Federal Register

**National Highway Traffic Safety
Administration**

**Anthropomorphic Test Devices; SID-II's
Side Impact Crash Test Dummy; 5th
Percentile Adult Female; Final Rule**

ACTION: Final rule, response to petitions for reconsideration, technical amendment.

Figure 1: Alignment of iliac wing, backer plate, and load cell/replacement¹⁶

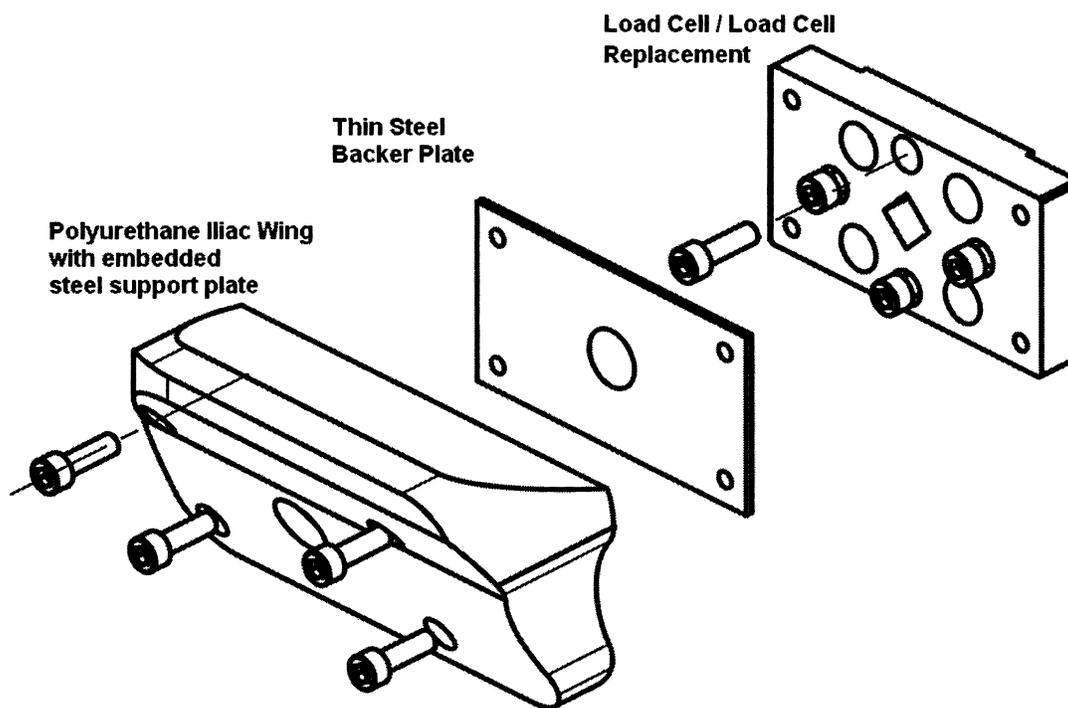
In response to the final rule, FTSS noted that, in general, the iliac wing specified in the final rule has the

propensity to cause a load path short due to its design. According to FTSS, the original iliac wing design resulted in 1/8-inch polyurethane material being sandwiched between the embedded iliac wing support plate and the iliac load cell. It found that the amount of loading force the iliac is able to accurately measure can vary depending upon how much torque the iliac mounting screws are under, how much the polyurethane material creeps over time, and how much the iliac maintains its original shape.

FTSS stated that it has designed a new iliac substructure (support plate) that has a positive bearing surface contact between the iliac wing and the load cell to create a rigid mounting surface between the iliac wing and load cell.¹⁷ Essentially, the 1/8-inch thick polyurethane material around the mounting screw holes was replaced with 1/8-inch thick steel “standoffs” that extend from the embedded plate to the edge of the wing so that the mounting screws would draw the iliac wing to the load cell through a metal contact instead of through polyurethane. According to FTSS, this design eliminated the

potential for load path shorting since standard fastener torque values can now be specified for the iliac wing mounting hardware without losing the torque over time, and it also eliminated the material creep found in the original iliac design. FTSS recommended that NHTSA evaluate this new design and include it in the drawing package in place of the original.

artificially low measurements.” It stated, however, that while the use of the thin steel backer plate specified in the final rule (as shown in Figure 1) will reduce the likelihood of off-loading the load cell, it will not reduce deformation of the polyurethane iliac wing. It suggested that a more robust solution would be to use a rigid steel plate with standoffs that are embedded in the polyurethane iliac wing during manufacturing. The Alliance stated that “this stronger plate with standoffs eliminates the possibility of off-axis loading.”

plate between the wing and load cell, as specified by the final rule (Table 2). VRTC found that qualification test results from these two iliac configurations were very similar. The average response from wings without a backer plate was always lower than that from wings with a backer plate as seen in Table 2, but was also always less than a 2.5% reduction from the response with a plate.²⁰ Thus, the influence of the backer plate appears to be negligible. However, the plate can act to prevent load path shorting through wing contact with the center of the load cell. Although there were no instances of load path shorting during qualification tests without a plate, two quasi-static tests without a backer plate were conducted on both the softest and stiffest M3 iliac wings with standoffs. In this set of tests, the softest iliac wing made contact with the center of the load cell at a load of about 3,700 N (831.8 lb). To prevent this from happening, we have decided to retain use of the thin steel backer plate between the iliac wing and iliac load cell.

Figure 2: Examples of pelvis-acetabulum, pelvis Y acceleration response traces

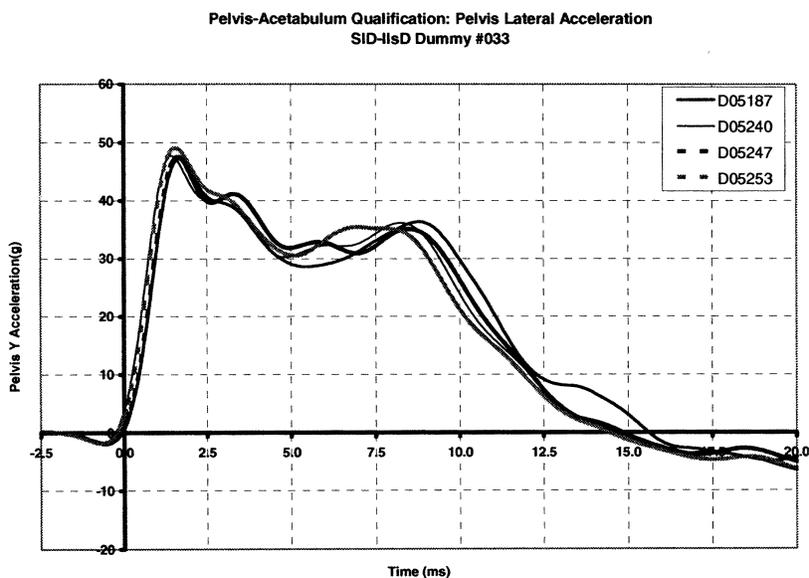
section, the first peak of the pelvis lateral acceleration response, which occurs in the first 5–6 ms, is based primarily on the plug response. Since the pelvis-acetabulum test aims to verify the pelvis response, not the plug response, the acceleration during the first 5–6 ms should not be included. However, NHTSA examined pelvis lateral acceleration traces in 11 side impact crash tests conducted with the SID-II's Build Level D dummy to determine if the first peak, which results from initial pelvis plug crush in qualification tests, was part of the dummy response in vehicle tests. (If the first peak were part of the dummy response, we would be disinclined to disregard this peak in dummy qualification.) Crash test results showed generally unimodal pelvis Y accelerations, indicating that in vehicle tests, the initial plug crush does not play a significant role in the results.

To determine after what point in time the peak lateral pelvis acceleration should be taken, NHTSA analyzed pelvis lateral acceleration traces for 46 pelvis-acetabulum qualification tests from four dummies and two labs. The data clearly showed multiple, distinct peaks as seen in Figure 2. As mentioned previously, the first main peak and second small "bump" in the data are due to the pendulum impacting the pelvis plug and (most likely) the pelvis flesh, respectively. The second major peak (called the "second peak" henceforth) represents the response of the dummy after the leg mass comes into play, and is the measure of interest for qualification of the dummy. As the petitioners claimed, the first peak was consistently higher than the second peak. In order to prevent measuring this first, less meaningful peak for qualification, the petitioners recommended that the peak pelvis acceleration value be taken after 5 ms after probe contact with the dummy.

Figure 3: Pelvis Y acceleration traces (with the exception of D05149) with main response peak values lower than the acceleration at 5 ms

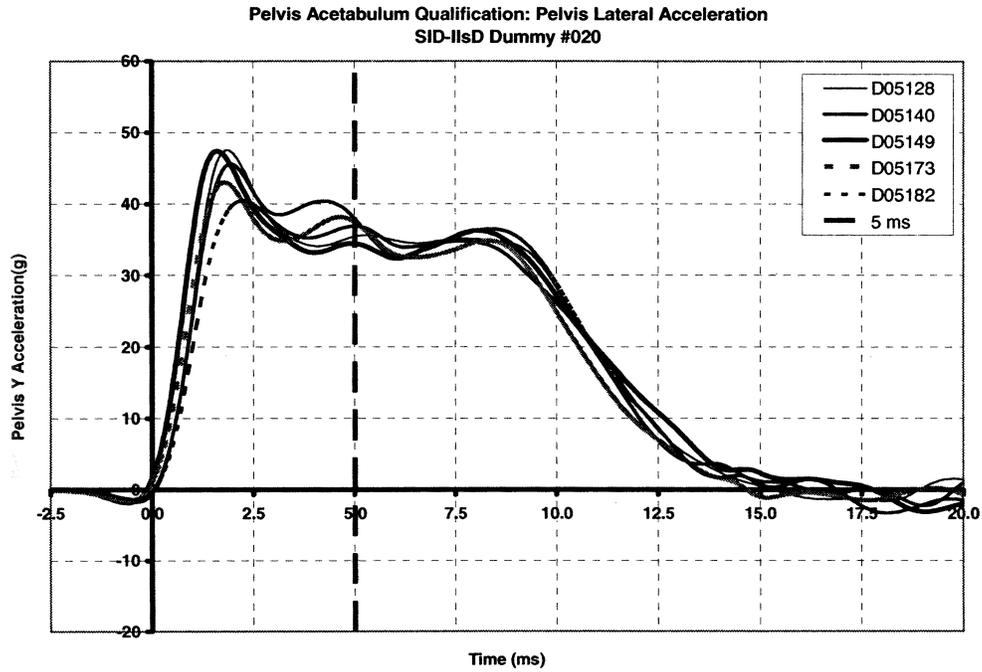
It was not clear from the data that 5 ms was the most appropriate time to begin measuring a peak value. For each of these 46 traces, the peak values after 5 ms, 6 ms and 7 ms were obtained in order to determine how much time after probe impact should be disregarded to prevent the first peak from being measured. It was found that in five of the 46 tests, the maximum value after 5 ms was higher than that after 6 or 7 ms, because the value of the decreasing “first peak” response at 5 ms was higher than the main dummy response peak value. Four of these 5 instances occurred in Dummy S/N 20, and are seen in Figure 3 below. These cases led the agency to determine that the peak should be taken after 6 ms. However, in

Figure 4: Tests 056(01)PV1 and 056(02)PV2 have main response peaks occurring slightly before 6 ms

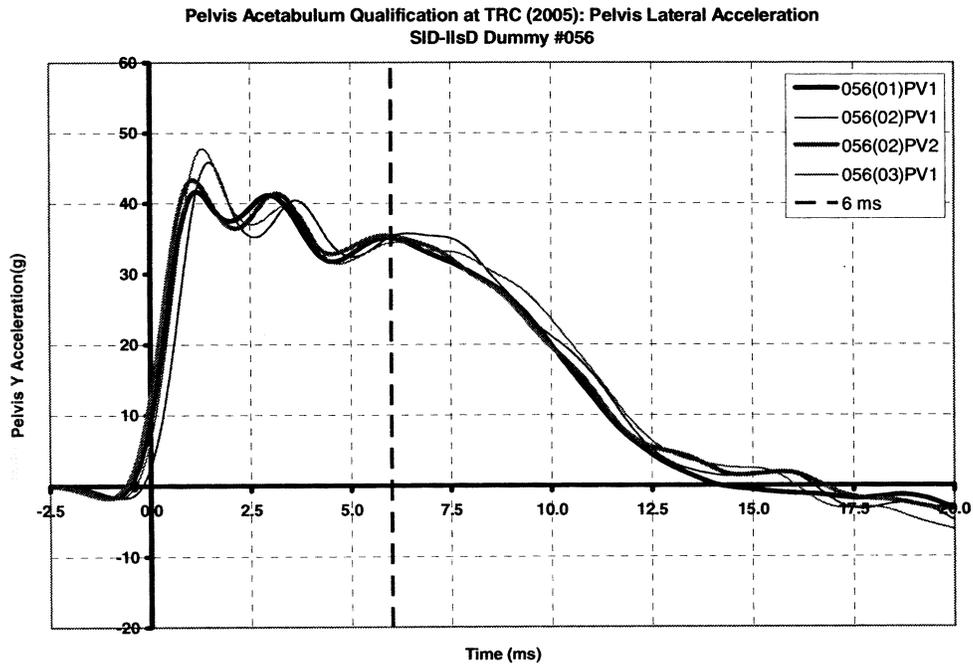
two tests, the peak of the main dummy response occurred just before 6 ms (see Figure 4), causing the peak after 6 ms to be slightly less than the actual peak. This occurrence was rare, though, and only resulted in an error of approximately 0.1 g for both tests. As a result of this evaluation, this final rule specifies that the peak pelvis lateral acceleration be taken after 6 ms.

Figure 5: Peak shoulder deflections generated at probe impact velocities of 4.2 – 4.5 m/s

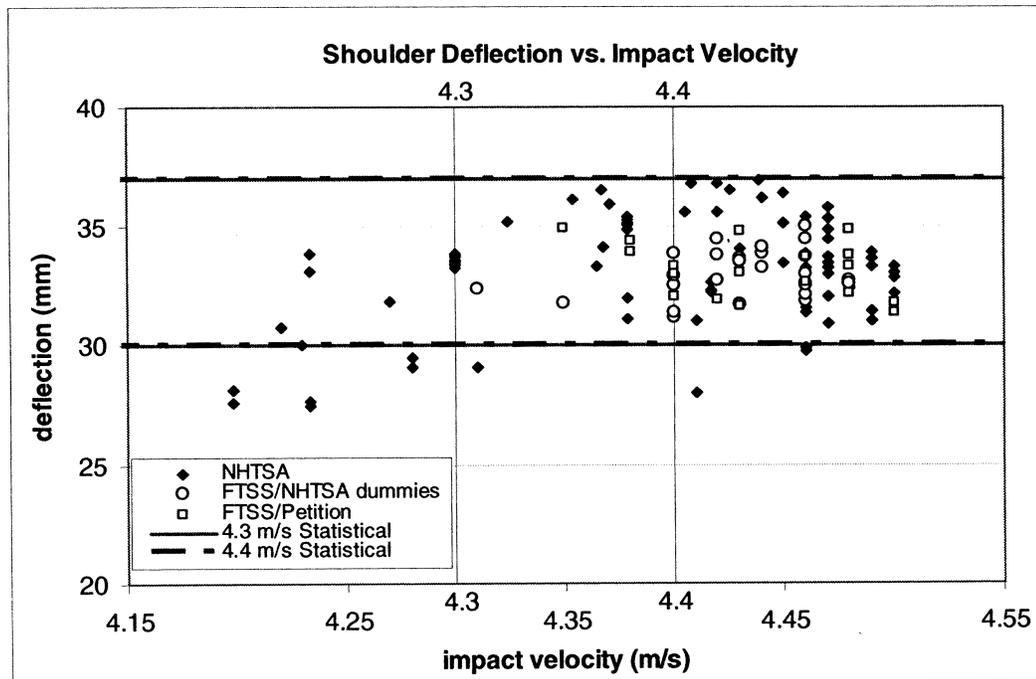
Figure 5 shows the peak shoulder deflection responses with respect to the impact speed of the pendulum. It is observed that the peak deflections are noticeably lower at impact speeds of approximately 4.2 m/s. Because of this observation, the qualification performance corridors have been formed with the mindset that the statistical corridor (which is centered at the mean

of the data set) may have to be adjusted to accommodate low deflections at the low impact velocities, since the mean of the 4.2–4.4 m/s data set may be slightly high due to the majority of tests being conducted between 4.3–4.4 m/s. The revised corridors are discussed in “Analysis and Development of SID–IIIsD Qualification Specifications in Response to Petitions for Reconsideration (July 1,

2008),”³¹ and in section XI.a of this preamble. We believe that by adjusting the performance corridor to reflect deflection responses at lower impact velocities, the new performance corridor will satisfactorily represent dummy responses over the full range of the revised specified impact velocities.

**FIGURE V4-A
SHOULDER IMPACT**

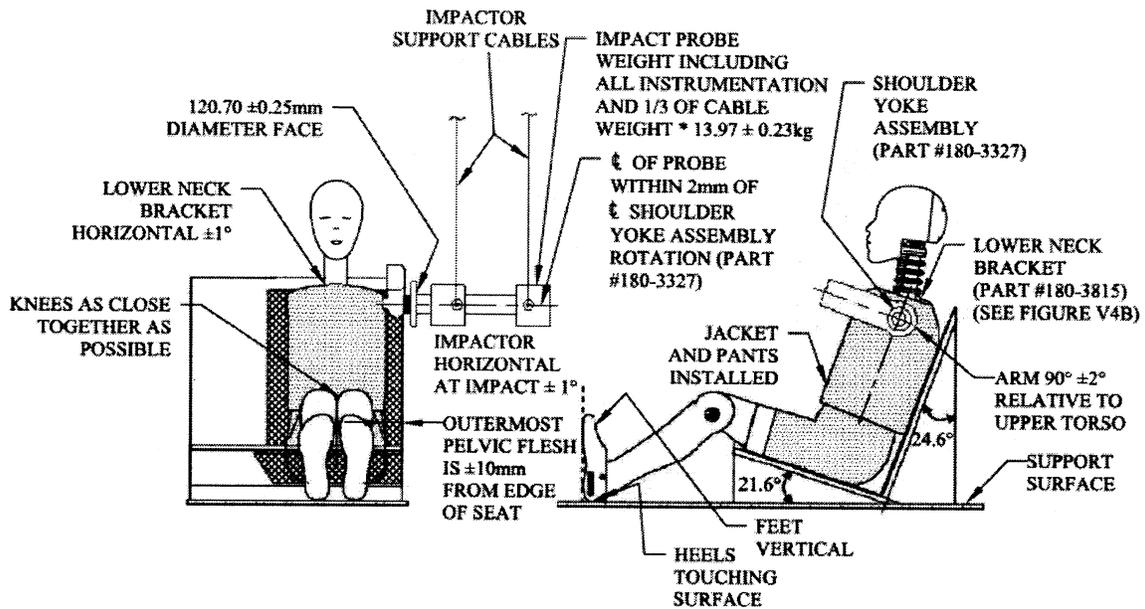
■ 13. Figures V4-A, V9-A and V9-B in "Appendix A to Subpart V of Part 572-Figures" are revised to read as follows:

**FIGURE V9-A
ILIAC IMPACT**

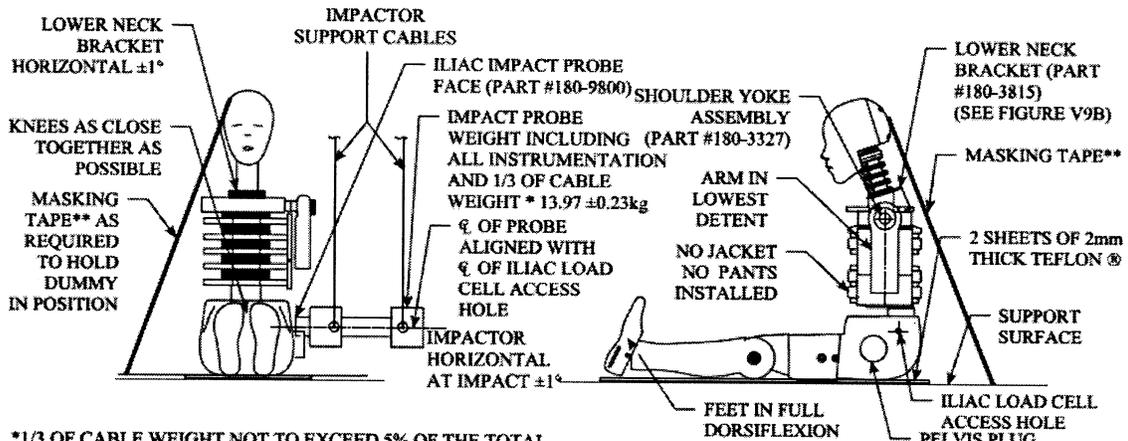
(5) The midsagittal plane of the dummy is vertical, and superior surface of the lower half neck assembly load cell replacement (180-3815) in the lateral direction is within ±1 degree relative to the horizontal as shown in Figure V9-A.

**FIGURE V9-B
ILIAC IMPACT
(NON-IMPACT SIDE VIEW)**

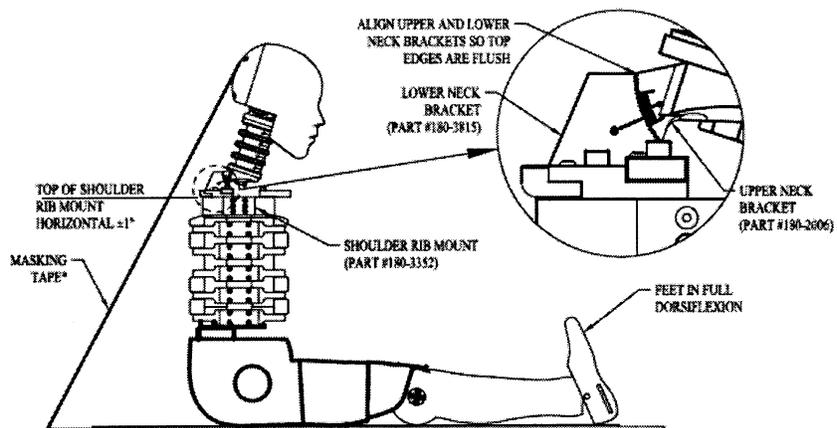
(6) While maintaining the dummy's position as specified in paragraphs (b)(3), (4) and (5) of this section, the top of the shoulder rib mount (180-3352) orientation in the fore-and-aft direction is within ±1.0 degree relative to horizontal as shown in Figure V9-B in Appendix A to this subpart.
